**Economic Commission for Europe****Inland Transport Committee****World Forum for Harmonization of Vehicle Regulations****Working Party on Passive Safety****Sixtieth session**

**Regulation No. 44 (Child restraints systems)****Proposal for Supplement 13 to the 04 series of amendments  
to Regulation No. 44 (Child Restraint Systems)****Submitted by the expert from the Netherlands\***

Paragraph 6.1.8., amend to read:

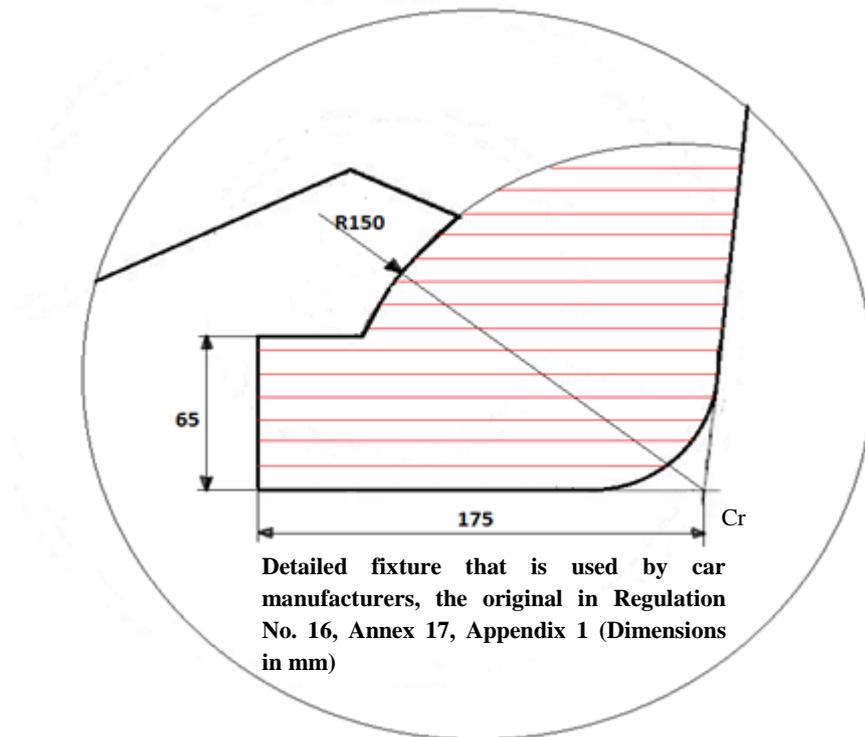
"6.1.8. Child restraint systems of the "universal" category, except ISOFIX universal child restraint systems, shall have a main load-bearing contact point, between the child restraint and the adult safety-belt. This point shall not be less than 150mm from the Cr axis when measured with the child restraint on the dynamic test bench installed in accordance with Annex 21 to this Regulation without a dummy. ~~This shall apply to all adjustment configurations. Additional alternative belt routes are allowed.~~

**Moreover, in the zone with red horizontal lines, there may be contact by means of flat support of the adult safety belt, however, no part of the child restraint shall hinder the lap belt of the adult from following its intended design and use.**

**The main load-bearing contact point is the part of the child restraint that makes that the lap belt will sustain tension forces in the longitudinal direction and transverse forces from the restraining function.**
